QUALITY ASSURANCE -- NON-CONFORMANCE REPORT

Report No: NCR-000586

Reference Description: West Tower, Lift 2 to 3, Skin D Interior Splice Plate

To:	AMERICAN BRIDGE/FLUOR, A JV 375 BURMA ROAD OAKLAND CA 95607	Date:	04-Jan-2010
Dear:	Mr. Charles Kanapicki	Contract No:	04-0120F4 04-SF-80-13.2 / 13.9
Attention:	Mr. Thomas Nilsson Project/Fabrication Manager	Job Name:	SAS Superstructure
Subject:	NCR No. ZPMC-0559	Document No:	05.03.06-000549

Reference Description: West Tower, Lift 2 to 3, Skin D Interior Splice Plate

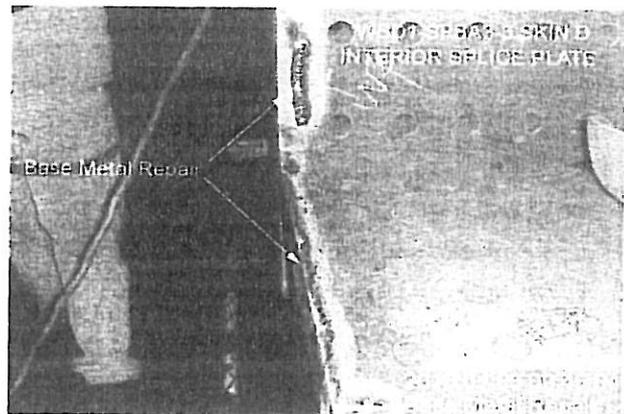
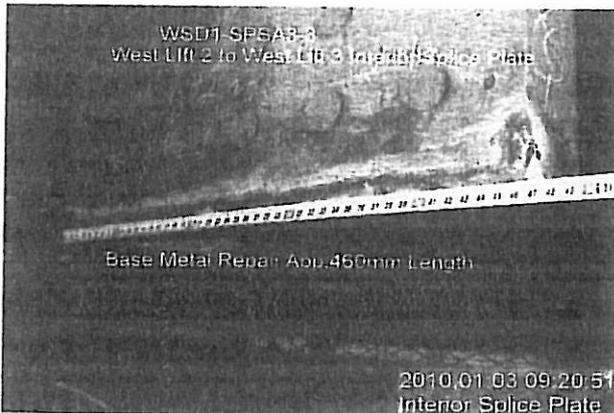
During in-process Visual Testing (VT) of West Tower, Skin D, Interior Splice Plate WSD1-SPSA3-3, QA discovered base metal repairs performed without prior Engineer approval.

项目名称 Project Name	美国海湾大桥 SFOBB	部件图号 Drawing No	SPSA3-3	报告编号 Report No.	T-WR2904
合同号 Contract No.:	04-0120F4	部件名称 Items Name	西二三吊内部连接板 2 nd 3 rd lifting inner connect plate	NDT报告编号 Report No.of NDT	NA
项目编号 Project No.:	ZP06-787

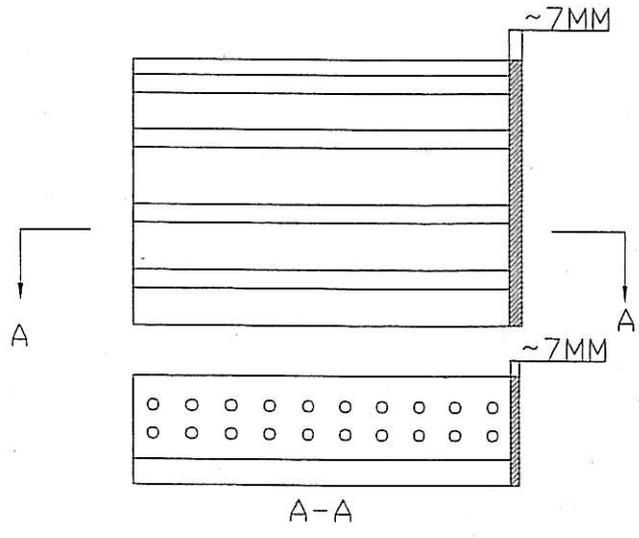
西二三吊栓接段内部连接板SPSA3-3端部孔边距与工艺要求不符，需要进行堆焊约7MM，如图：
After inspection west tower 2nd 3rd lifting bolt segment connect plate SA3-3 hole distance, it can't meet technology requirement, it needed to build up 7mm, see draft.

注：阴影处为需修补区域。Remark: repair area in shadow.

Weld distortion and fabricate error.

1. QC shall monitor gouging/grinding/welding
2. Grind the building-up area
3. Verify that defects have been removed with VT
4. Preheat and weld passes temperature according to the approved WPS, it should be 2-3mm than the theory size
5. Grind the weld area smoothly after repairin
6. Perform VT, MT, & UT to repaired area.
